# PITTSBURG UNIFIED SCHOOL DISTRICT

## DISTRICT SERVER ROOM HVAC PROJECT

**Bid No. 17-001**

**Addendum No. 1**

**PIPE SUPPORT ON GRADE DETAIL**

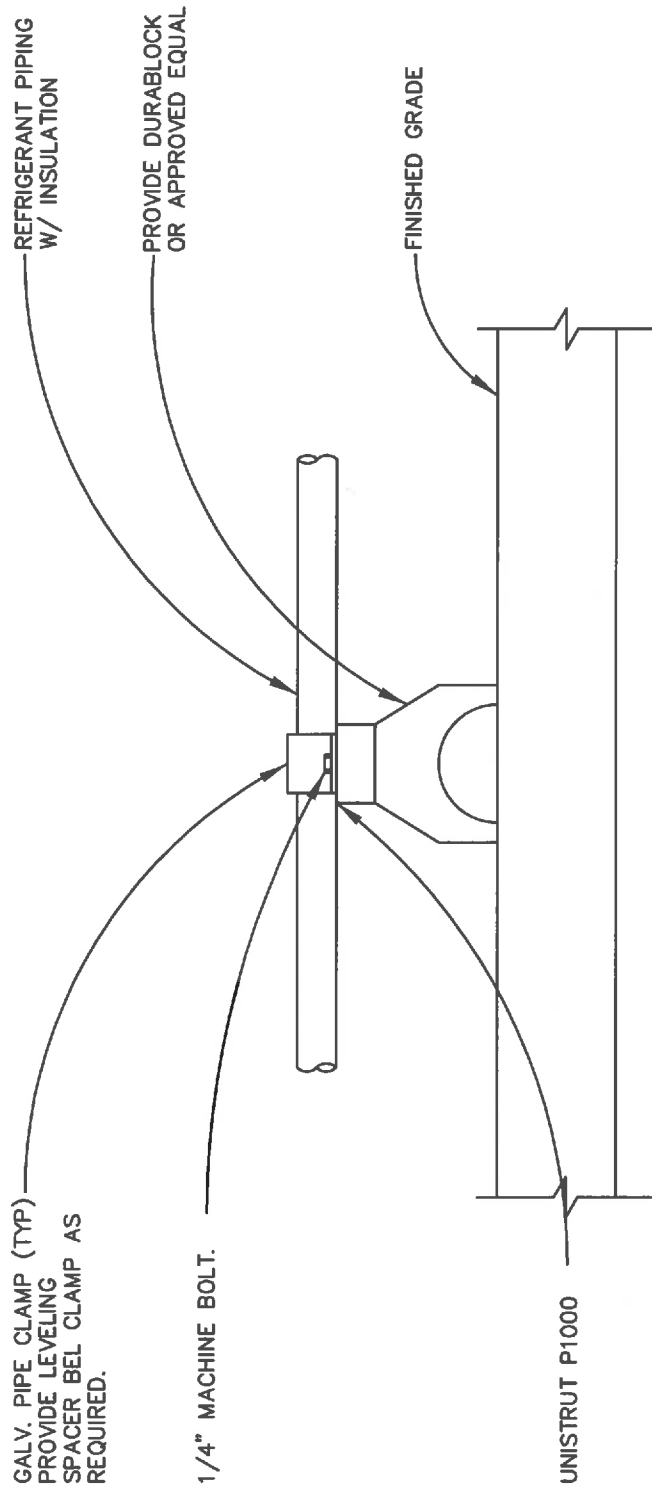
Sheet M2.0 Construction key note #14 tell us to secure the pipe supports to grade. The pipe support detail on 7/M6.0 show the mounting detail bolting down to concrete.

Please provide a mounting detail for the refer pipe running on the grade.

See attached detail.

1. COORDINATE WITH MANUFACTURER TO ENSURE PROPER INSTALLATION IN ACCORDANCE WITH ALL WARRANTIES, EXISTING OR NEW, AND SO AS NOT TO VOID SUCH WARRANTIES.
